#### PLANNED UNIT DEVELOPMENT STAFF REPORT Date: September 4, 2003

**DEVELOPMENT NAME** Greene & Phillips Subdivision

**LOCATION** 30, 50 and 52 North Florida Street

# SITE PLAN

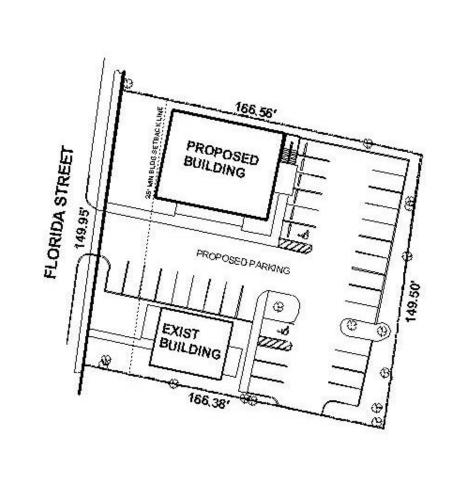
<u>COMMENTS</u> Elimination of Four parking spaces, two on the Northeast and two on the Northwest to accommodate critical root zone of an existing 40" oak on the North property line. All parking surfaces under the drip line of the tree to be of an alternative parking surface. All work to be coordinated with Urban Forestry.

There are a couple of points relating to the proposed site development that should be taken into consideration. The first relates to the comments from Urban Forestry. The site plan indicates 34 parking spaces, 13 more than are required by the Ordinance (21); therefore, compliance with the UF request to eliminate four spaces to accommodate the critical root zone of a 40" tree could easily be accomplished.

Additionally, the UF requests that alternative parking surface for spaces under the drip line of the tree be provided. Based on aerial photographs, it appears that this requirements would also allos for some protection of trees located along the East property line. Additional protection of these trees would be beneficial to maintain buffering between the site and the adjacent residential properties. Especially since the proposed building is two-story, which is not characteristic of development along this section of Florida Street.

**RECOMMENDATION** Based on the preceding, it is recommended that this application be approved subject to the following conditions: 1) Elimination of four parking spaces, two on the Northeast and two on the Northwest to accommodate critical root zone of an existing 40" oak on the North property line; 2) All parking surfaces under the drip line of the tree to be of an alternative parking surface; 3) All work to be coordinated with Urban Forestry; and 4) full compliance with all municipal codes and ordinances.
